ADDENDUM NO. 1

DATE: February 11, 2016
FROM: City of Grand Junction Purchasing Division
TO: All Offerors
RE: IFB-4168-16-DH Motor Control Centers Replacements for Persigo WWTP Phase IV

SECTION 31E ONE LINE DIAGRAM MCC-6

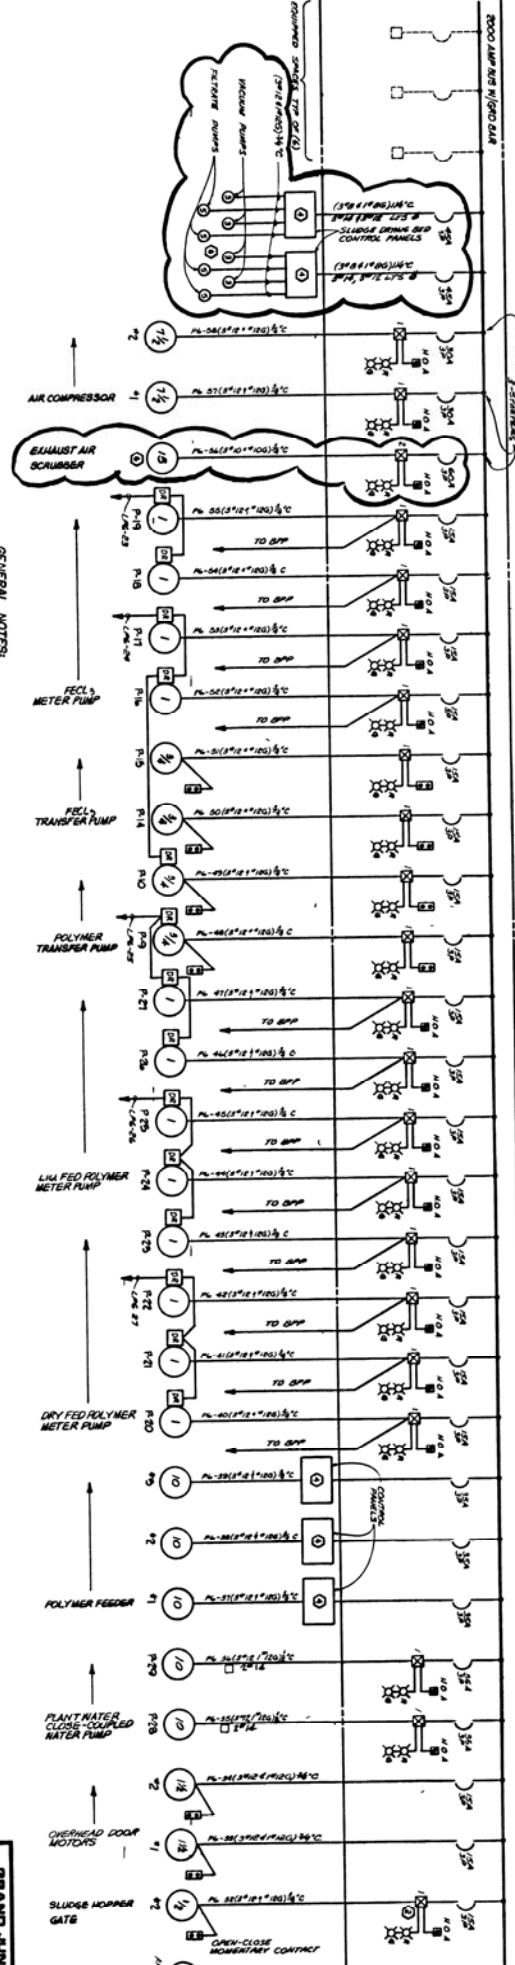
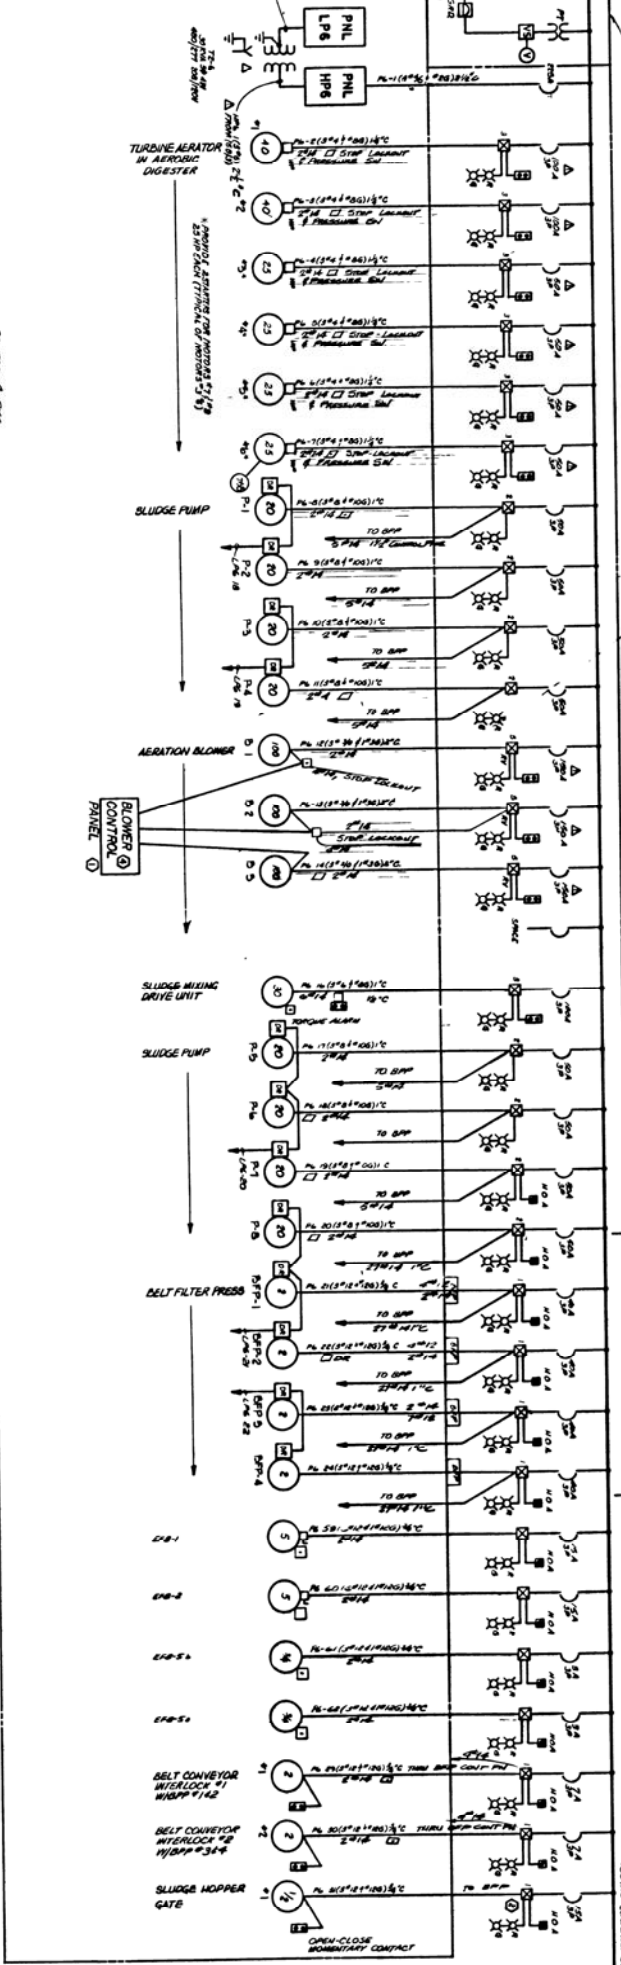
- A. Yes it will need to be GFI
8. Q. Are there any one line drawings for the MCC or component spec sheets for the equipment being supported by the MCC shown on Page 19?
- A. Please see the original line drawings. NOTE: These are drawings are upwards of 35 years old and are **not** accurate.
9. Existing curbing shall be removed and new curbing installed to the proper dimensions of the new equipment, by the Contractor.
10. Contractor needs to be award of the logistics of the project. The majority of this project is located on the second floor of the building.
11. Contractor needs to utilize shipping splits for equipment delivery.
12. Contractor needs to pay attention to the mains and conduits coming in through the floor, and take these into account for the project.
13. See attached revised load list developed from the site visit.
14. See attached site visit sign in sheet.

1. ALL MOTORS TO HAVE ELASATED TIME SETTERS LOCATED IN THE MCC.
2. HEAVY AND COORDINATE EXISTING WIRING REQUIREMENTS FOR CONTROLS.
3. WIRING CONTROLS COORDINATE EXISTING SIGNALS, STARTS, STOP AND STOPPING.
4. ALL WIRING TO BE CONTROLLED BY MCC AT STARTER.
5. ALL CIRCUIT BREAKERS IN MCC TO BE WATED AT 480V AC.
6. FEEDER TO PANEL 105 SHOULD BE IN 2" C.
7. Polymer transfer pump (P-1 and P-2) should be changed from 115V to 230V.
8. The plant water close-coupled water pump (P-10 and P-11) should be changed from 230V to 480V. Change transfer wires to (3) 1/2" (3) 1/2" & (1) 3/4" 250 CIRCUIT BREAKER.
